STATE OF WASHINGTON
DEPARTMENT OF ECOLOGY

Re: Further Action at a Property associated with a Site:

- **Property Address:** 258010 HWY 101, Port Angeles, Washington 98362
- **Facility/Site No.:** 1671323
- **Cleanup Site ID:** 958
- **VCP Project No.:** SW1202

Issues Presented and Opinion

Site Investigation Plan

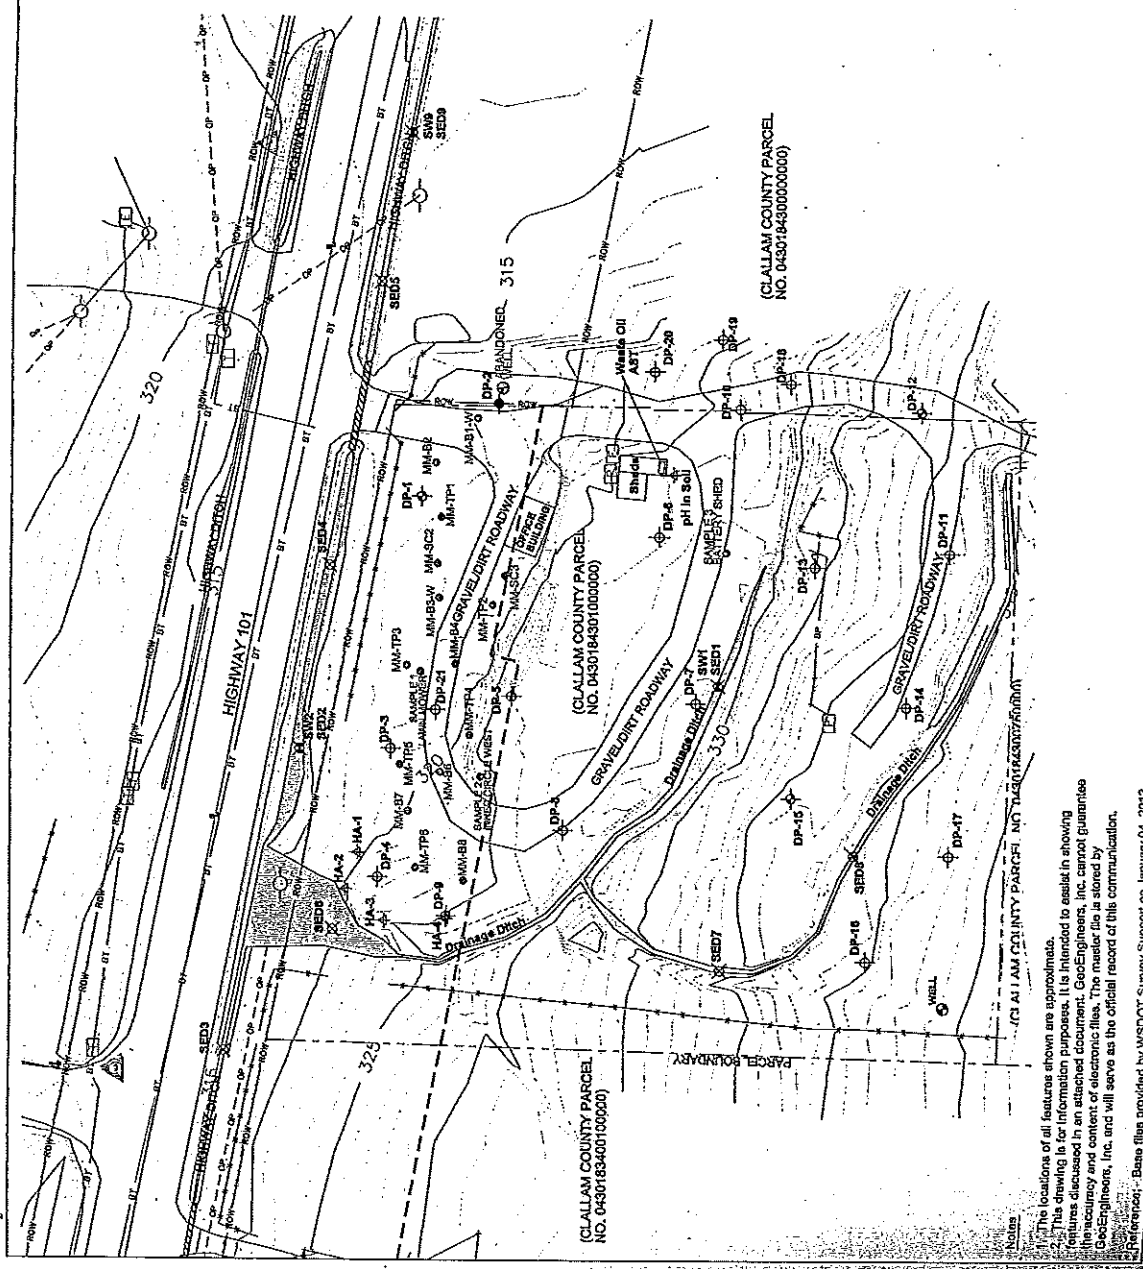
1. Metals-contaminated soil (MCS) and petroleum-contaminated soil (PCS) remain on the Site above their applicable MTCA CULs. PCS and MCS near *MM-SC2*, *MM-SC3*, *DP-10-0.0-2.0*, and *Sample 3 Batteries* has not been delineated in the full vertical extent and only partially delineated in the horizontal extents. Ecology recommends delineating the PCS and MCS in the full spatial extent. Ecology also recommends removal of source material.

2. cPAHs above their applicable MTCA CULs were identified in the sediment sample collected at *Sed5*. The vertical and horizontal extents of cPAHs at that location have not been delineated. Ecology recommends delineating the cPAHs in the full spatial extent.

3. Metals and PCB contamination above their applicable MTCA Method B CULs has been identified in surface water from the drainage ditch located on the northern boundary of the Site. Ecology recommends continued monitoring of the surface water for these COCs. Further, Ecology suggests using a more sensitive analytical method for PCBs that will resolve analysis results to below the applicable MTCA Method B CULs.

4. Metals contamination above their applicable MTCA CULs was found in the shallow perched water table. Total lead and total arsenic were detected above their respective MTCA Method A CULs. No source for the arsenic has been identified on the property; however, analytical results indicate a lead source (*Sample 3 Batteries*) in the Site soil. Ecology recommends removal of that potential lead source. Ecology also recommends the installation of permanent groundwater monitoring wells for additional groundwater monitoring. Alternately, a demonstration (per WAC 173-340-720) to quantify or qualify the groundwater as a non-potable source may be made and presented to Ecology for approval.
